Design Statement – Proposed Garden Main Entrance Gates

Since the indicative landscaping proposals submitted at planning (April 2013) the applicant has revised the design of the Garden Main Entrance Gates. These amendments have had regard to the comments raised by London Borough of Camden Parks Officers at the time of the original application (comments from J. Gibbons 15/05/2013).

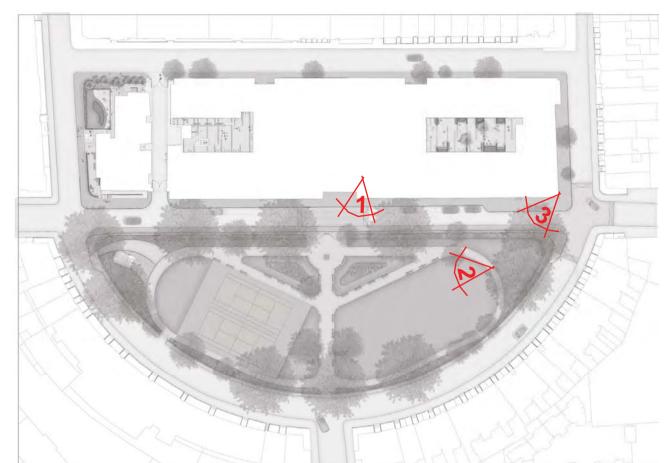
"A wider, more welcoming, main entrance is also welcomed, although there are concerns regarding the illustrated design (wide leaf gates and two wide low arches). It is important that the treatment of this entrance is of a scale appropriate to the site, in keeping with historical character of the space, and also that it does not compromise the security of the space by making it easier to scale the railings".

The revised proposals continue to propose a wider, more welcoming, main entrance allowing greater access with the proposed installation of 2 new entrance gates.

The gates are now proposed to match the existing boundary treatment of the park to complement the park's scale and historic context.

Each double swing gate will be constructed of identical railings which are square in section and have pointed finials that currently run on the perimeter of the park (painted in black).

Each double swing gate when fully opened will provide an entry clearance of 5 metres. These entry points use a set of hexagonal posts which define each opening and are identical in design to the existing which are currently used to the parks single swing gates.

When the park is closed a sliding bar connecting the two swings and secured by a heavy duty padlock and key comes into play. Each swing will also have a dead bolt into a ground stone / slab flush to the parks finished surface and again secured by a heavy duty padlock and key. This same system will be implemented when the gate swings are open. The height of the gates is as per existing to also ensure that the existing levels of security are retained in the new proposals.

The existing concrete up-stand below the railings will be sensitively refurbished and cut out where new openings are formed.
